NEEDS ASSESSMENT AND LEVEL OF SERVICE EVALUATION

APPENDIX D: AMERICANS WITH DISABILITIES ACT (ADA) FACILITY BARRIER REPORT

Americans with Disabilities Act (ADA) Facility Barrier Report

For Selected Park Sites

Rockwood Central Park

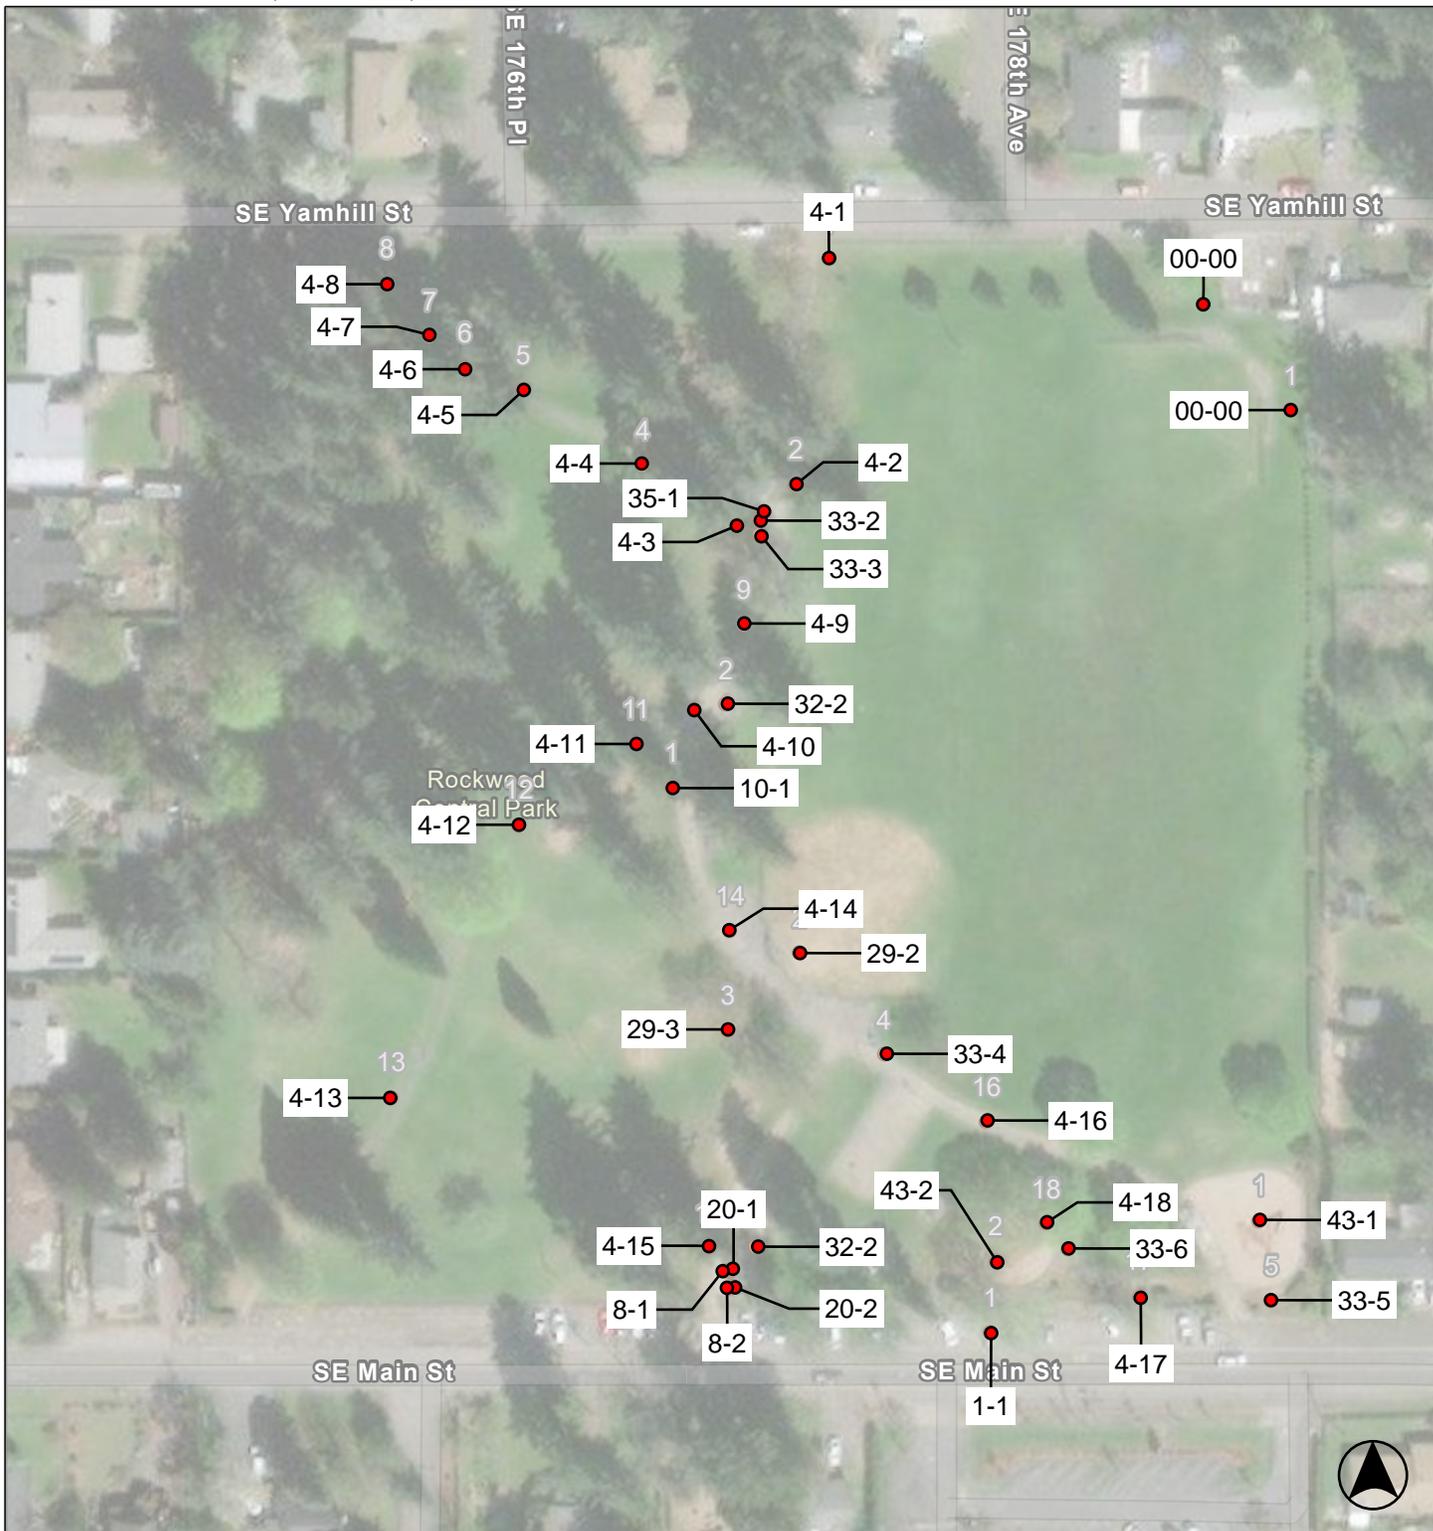
Park	
1 - 1	Parking Area Category: 1
Provide or modify accessible spaces	\$4,050
Notes: Parking lot with 54 total parking spaces of which zero are accessible parking spaces. Two additional spaces are needed (0 min space(S); 26 to 50 parking spaces).	
ADA: 208.2	
Other: OSSC 1106.1	
Provide a firm, stable and slip resistant surface	\$0
Notes: Parking space and access aisle is not firm and stable.	
ADA: 302.1, 502.4	
Other: -	
Provide adequate striping	\$180
Notes: A marked access aisle is not provided.	
ADA: -	
Other: OSSC 1106.7	
4 - 1	Walk Category: 1
Regrade surface	\$2,500
Notes: Running slope of concrete is up to 8.9% for 25 linear feet (5.0% max).	
ADA: 403.3	
Other: -	
Reduce or eliminate opening	\$300
Notes: Gap at concrete joint is greater than 1/2" (1/2" max).	
ADA: 302.3	
Other: -	
4 - 2	Walk Category: 1
Grind or patch vertical change of grade	\$100
Notes: Surface level change is 1/2" at concrete joint (1/4" max; up to 1/2" with a 1:2 bevel).

Park	
4 - 4	Walk Category: 1
Regrade surface	\$1,500
Notes: Running slope of concrete is up to 6.3% for 15 linear feet (5.0% max).	
ADA: 403.3	
Other: -	
Grind or patch vertical change of grade	\$100
Notes: Surface level change is greater than 1/4" at crack in concrete (1/4" max; up to 1/2" with a 1:2 bevel).	
ADA: 303.2, 303.3	
Other: -	
4 - 5	Walk Category: 1
Regrade surface	\$100
Notes: Running slope of concrete is up to 10.5% for 5 linear feet (5.0% max).	
ADA: 403.3	
Other: -	
Grind or patch vertical change of grade	\$100
Notes: Surface level change is greater than 1/4" at crack in concrete (1/4" max; up to 1/2" with a 1:2 bevel).	
ADA: 303.2, 303.3	
Other: -	
4 - 6	Walk Category: 1
Grind or patch vertical change of grade	\$100
Notes: Surface level change is 1/2" at crack in concrete (1/4" max; up to 1/2" with a 1:2 bevel).	
ADA: 303.2, 303.3	
Other: -	
4 - 7	Walk Category: 1
Regrade surface	\$300
Notes: Running slope of concrete is up to 5.9% for 3 linear feet (5.0% max).

ADA: 403.3	
Other: -	
Grind or patch vertical change of grade	\$100
Notes: Surface level change is 1/2" at crack in concrete (1/4" max; up to 1/2" with a 1:2 bevel). (x2)	
ADA: 303.2, 303.3	
Other: -

Park	
4 - 8	Walk Category: 1
Grind or patch vertical change of grade	\$100
Notes: Surface level change is 1" at crack in concrete (1/4" max; up to 1/2" with a 1:2 bevel).	
ADA: 303.2, 303.3	
Other: -	
4 - 9	Walk Category: 1
Grind or patch vertical change of grade	\$100
Notes: Surface level change is 1/2" at concrete joint (1/4" max; up to 1/2" with a 1:2 bevel).	
ADA: 303.2, 303.3	
Other: -	
Regrade surface	\$2,800
Notes: Cross slope of concrete is up to 5.1% for 28 linear feet (2.0% max).	
ADA: 403.3	
Other: -	
4 - 10	Walk Category: 1
Regrade surface	\$400
Notes: Cross slope of concrete is up to 2.6% for 4 linear feet (2.0% max).	
ADA: 403.3	
Other: -	
4 - 11	Walk Category: 1
Regrade surface	\$2,200
Notes: Cross slope of concrete is up to 3.6% for 22 linear feet (2.0% max).	
ADA: 403.3	
Other: -	
Reduce or eliminate opening	\$300
Notes: Gap at concrete joint is greater than 1/2" (1/2" max).	
ADA: 302.3	
Other: -

Park	
4 - 12	Walk Category: 1
Regrade surface	\$4,600
Notes: Running slope of concrete is up to 8.6% (5.0% max) and cross slope is up to 3.6% (2.0% max) for 46 linear feet.	
ADA: 403.3	
Other: -	
Grind or patch vertical change of grade	\$100
Notes: Surface level change is greater than 1/2" at concrete joint (1/4" max; up to 1/2" with a 1:2 bevel).	
ADA: 303.2, 303.3	
Other: -	
4 - 13	Walk Category: 1
Grind or patch vertical change of grade	\$100
Notes: Surface level change is 1" at crack in concrete (1/4" max; up to 1/2" with a 1:2 bevel).	
ADA: 303.2, 303.3	
Other: -	
4 - 14	Walk Category: 1
Regrade surface	\$12,200
Notes: Cross slope of concrete is up to 4.1% for 122 linear feet (2.0% max).	
ADA: 403.3	
Other: -	
4 - 15	Walk Category: 1
Regrade surface	\$5,100
Notes: Cross slope of concrete is up to 3.6% for 51 linear feet (2.0% max).	
ADA: 403.3	
Other: -	
Grind or patch vertical change of grade	\$100
Notes: Surface level change is greater than 1/4" at concrete joint (1/4" max; up to 1/2" with a 1:2 bevel).

Park	
4 - 17	Walk Category: 1
Regrade surface	\$2,200
Notes: Cross slope of concrete is up to 3.6% for 22 linear feet (2.0% max).	
ADA: 403.3	
Other: -	
Grind or patch vertical change of grade	\$100
Notes: Surface level change is 1/2" at concrete joint (1/4" max; up to 1/2" with a 1:2 bevel).	
ADA: 303.2, 303.3	
Other: -	
4 - 18	Walk Category: 1
Grind or patch vertical change of grade	\$100
Notes: Surface level change is 1" at concrete joint (1/4" max; up to 1/2" with a 1:2 bevel).	
ADA: 303.2, 303.3	
Other: -	
8 - 1	Door/Gate Category: 1
Adjust door closer	\$160
Notes: Door opening force is 7 lbs (5 lbs max).	
ADA: 404.2.9	
Other: OSSC 1102.1.2.5	
Regrade surface	\$625
Notes: Slope of the exterior landing is 3.6% (2.0% max).	
ADA: 404.2.4.4	
Other: -	
8 - 2	Door/Gate Category: 1
Regrade surface	\$625
Notes: Slope of the exterior landing is 3.7% (2.0% max).	
ADA: 404.2.4.4	
Other: -	
Replace door hardware	\$550
Notes: Door hardware is jammed; door was not operable at time of assessment.

Park	
10 - 1 Drinking Fountain	Category: 3
Confirm water flow compliance	\$0
Notes: Water service to the drinking fountain was disconnected at the time of the assessment. Flow height and angle could not be confirmed.	
ADA: 602.3, 602.6	
Other: -	
20 - 1 Single User Restroom	Category: 2
Install restroom sign	\$250
Notes: Replace sign. Sign contains hole and cracks that could cause injury. Letters are not tactile, braille is not provided beneath text.	
ADA: 216.8	
Other: -	
Replace or reposition fixtures	\$1,590
Notes: The water closet centerline is 18-1/2" from the wall (16" min to 18" max).	
ADA: 604.2	
Other: -	
Replace or reposition dispenser	\$160
Notes: The centerline of the toilet paper in front of the water closet is 12" (7" min and 9" max).	
ADA: 604.7	
Other: -	
Replace or adjust water controls	\$640
Notes: Water flow was not operational on the day of assessment	
ADA: 309.4, 606.4	
Other: -

Park	
20 - 2	Single User Restroom Category: 2
Install restroom sign	\$250
Notes: Replace sign. Broken edges could cause injury. Letters are not tactile, braille is not provided beneath text.	
ADA: 216.8	
Other: -	
Replace or reposition fixtures	\$1,590
Notes: The water closet centerline is 18-1/2" from the wall (16" min to 18" max).	
ADA: 604.2	
Other: -	
Replace or reposition dispenser	\$160
Notes: The centerline of the toilet paper in front of the water closet is 12" (7" min and 9" max).	
ADA: 604.7	
Other: -	
Replace or adjust water controls	\$640
Notes: Water flow was not operational on the day of assessment	
ADA: 309.4, 606.4	
Other: -	
29 - 1	Game and Sports Area Category: 2
Provide an accessible route	\$16,560
Notes: An accessible route to the baseball backstop is not provided. Route from the nearest path to the backstop is 207 linear feet over grass. Route from the public right-of-way is 85 linear feet over grass.

ADA: 206.2.2	
Other: -	
Enlarge accessible route	\$190
Notes: Clear width of the route to the player seating is 30 inches due to overgrown grass. (36" min wide).	
ADA: 404.2.3	
Other: -	
Provide wheelchair seating	\$1,800
Notes: Debris in the wheelchair space for players.	
ADA: 802.1	
Other: -

Park		
29 - 2	Game and Sports Area	Category: 2
Provide companion seating		\$1,780
Notes: Cross slopes in team wheelchair spaces are between 4.2 - 6.2% (2.0% max). (x2)		
ADA: 221.3, 802.3.1, 802.3.2		
Other: -		
29 - 3	Game and Sports Area	Category: 2
Provide an accessible route		\$8,000
Notes: Multiple disc golf launch pads are not connected via an accessible route. Estimated total length of missing routes is 100 ft.		
ADA: 206.2.2		
Other: -		
32 - 1	Picnic Area	Category: 2
Provide an accessible table		\$3,250
Notes: Knee clearance measured 8" horizontally from the front face of the table top is 24" (27" min).		
ADA: -		
Other: ABA 306.3		
32 - 2	Picnic Area	Category: 2
Provide an accessible table		\$3,250
Notes: Knee clearance measured 8" horizontally from the front face of the table top is 24-1/2" (27" min).		
ADA: -		
Other: ABA 306.3		
Reduce or eliminate opening		\$300
Notes: The picnic area has 1-1/2" openings at gap between the path and picnic area (1/2" max).

Park	
32 - 3 Picnic Area	Category: 2
Increase or provide clear floor area	\$200
Notes: The clear space around the picnic table narrows down to 24" (36" min wide).	
ADA: -	
Other: ABA 1011.2.1	
Provide an accessible picnic unit	\$4,060
Notes: The picnic facility provides four picnic units and one are designed for accessibility (20% min but not less than two picnic units are required to be accessible). At least two accessible picnic units are required.	
ADA: -	
Other: ABA F245.2.2	
33 - 1 Outdoor Constructed Features	Category: 3
Increase or provide clear floor area	\$200
Notes: A clear floor space is not provided at the trash container opening (36" by 60" min parallel approach or 36" by 48" min forward approach).	
ADA: -	
Other: ABA 1011.2	
33 - 2 Outdoor Constructed Features	Category: 3
Increase or provide clear floor area	\$200
Notes: Clear floor space at the trash container opening has a 2" change of level and gaps greater than a 1/2" (36" by 60" min parallel approach or 36" by 48" min forward approach).

ADA: -	
Other: ABA 1011.2	
33 - 3 Outdoor Constructed Features	Category: 3
Increase or provide clear floor area	\$200
Notes: The clear ground space adjacent to the bench is 30" deep (36" by 48" min).	
ADA: -	
Other: ABA 1011.2.1, ABA 1011.2.3	
33 - 4 Outdoor Constructed Features	Category: 3
Increase or provide clear floor area	\$200
Notes: The clear floor space for the trash container has a cross slope of 3.8% (2.0% max).	
ADA: -	
Other: ABA 1011.2

Park	
33 - 5	Outdoor Constructed Features Category: 3
Provide an accessible route	\$1,200
Notes: An accessible route to the fixed bench is not provided. Route is 15 linear feet over woodchips from curb to bench.	
ADA: - Other: ABA F206.2.2	
33 - 6	Outdoor Constructed Features Category: 3
Increase or provide clear floor area	\$200
Notes: A clear ground space is not provided adjacent to the bench (36" by 48" min). Companion space overlaps with the path of travel.	
ADA: - Other: ABA 1011.2.1, ABA 1011.2.3	
35 - 1	Other Category: 3
Reposition controls	\$285
Notes: Operating mechanism of dog bag station is 65" above the ground (15" min to 48" max).	
ADA: 308.2, 308.2.1 Other: -	
Increase or provide maneuvering or clear floor area	\$200
Notes: Clear floor space of the dog bag station contains an elevation change of 1/2" (1/4" max).	
ADA: 305.2, 305.3, 305.5 Other: -	
43 - 1	Play Equipment Area Category: 2
Improve or evaluate play area surface	\$0

Notes: Ground surface in play area is in need of maintenance and further evaluation of fall attenuation surface is recommended.	
ADA: 1008.2.6.1, 1008.2.6.2 Other: -	
Provide play components	\$19,050
Notes: The play area has 9 elevated play components of 3 different types, with 0 ground components (for 8 to 10 elevated play components, 3 min ground components of 3 different types are required).	
ADA: 1008.2.1, 240.2.1.2 Other: -
